Hurstville Civic Centre Precinct Masterplan: Planning Proposal Urban Design Assessment

Prepared for
George's River Council

Issued
25 February 2019

Figure 5.8.1 Access and Movement Structure Plan

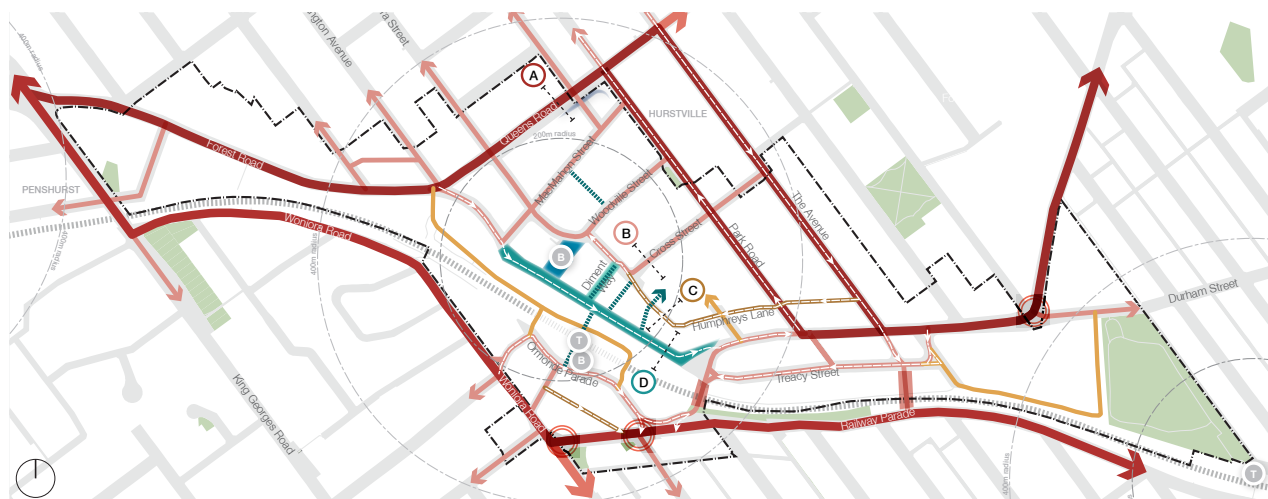
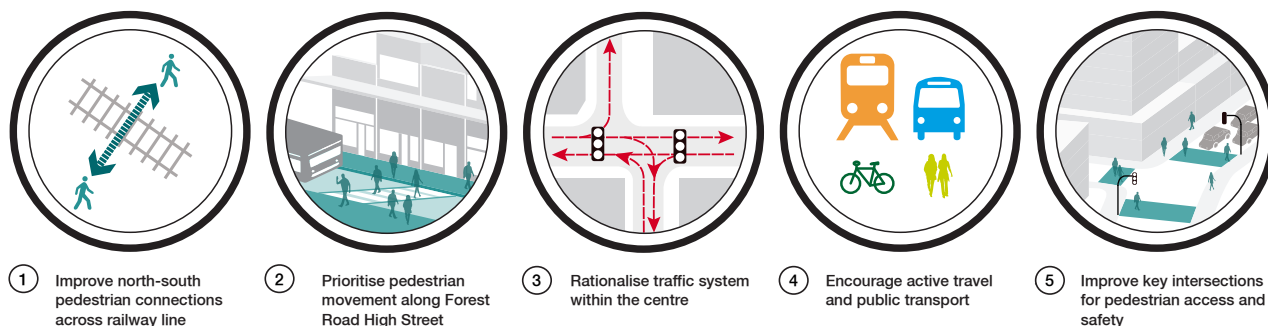
The role and hierarchy of the streets outlined in this framework plan should be addressed through the location of car parking and service access points to avoid conflicts with the high-trafficked roads (Park & Queens), and streets with the potential for improved pedestrian amenity (most notably MacMahon Street.

Figure 5.13.1 Public Domain and Open Space Structure Plan

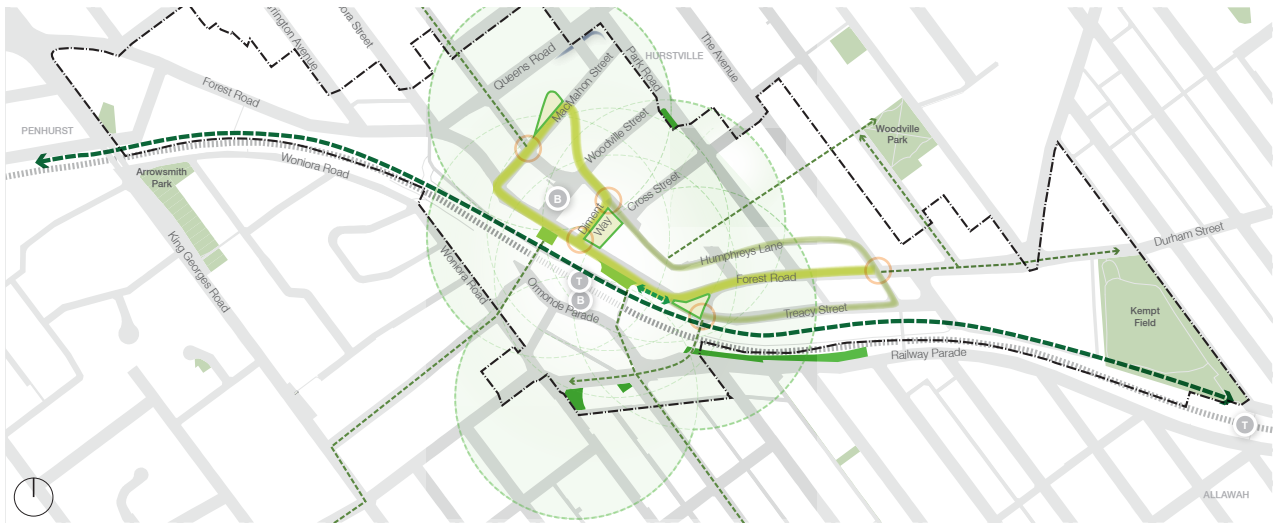
Outlined below are a number of specific design principles relating to open space, some of which have been addressed as part of the analysis. Many of these can be addressed during the DA stage, including those relating to 'planting' and 'passive and active amenity'. However, the framework plan reinforces the importance of 'solar access' to public domain, which has been suggested to be addressed in greater detail and weight in the proposed controls.

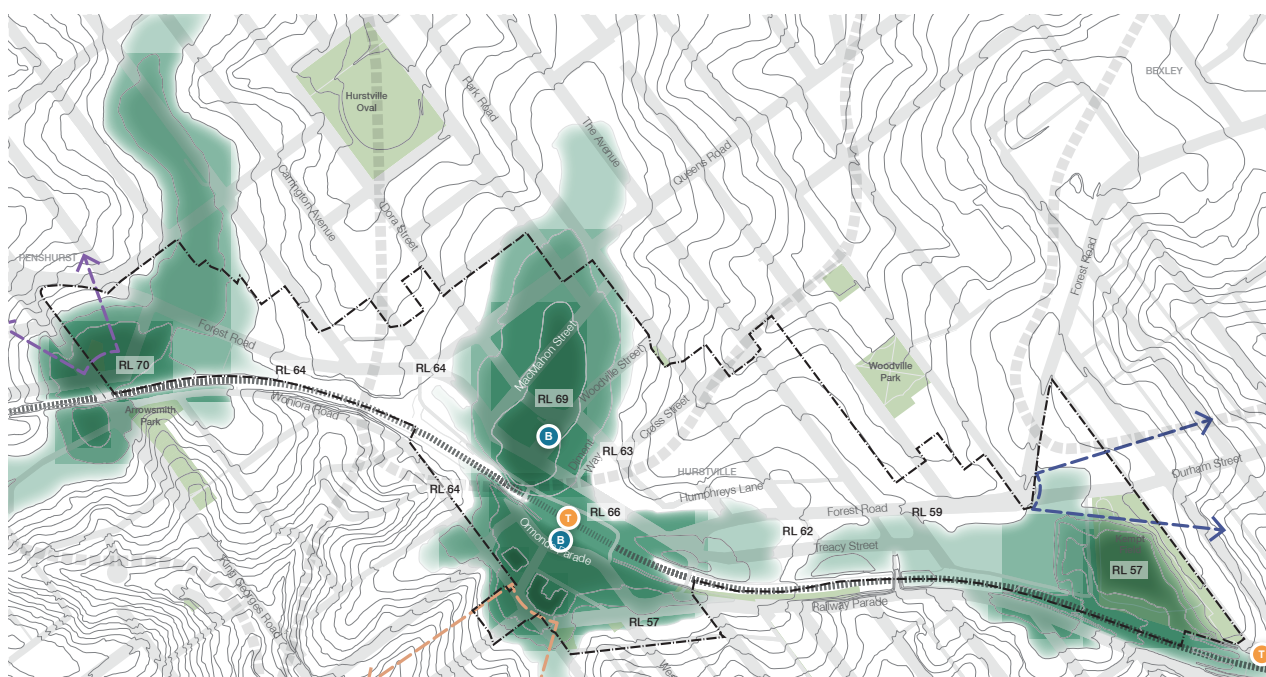
This approach is consistent with the approach to height in the planning proposal.
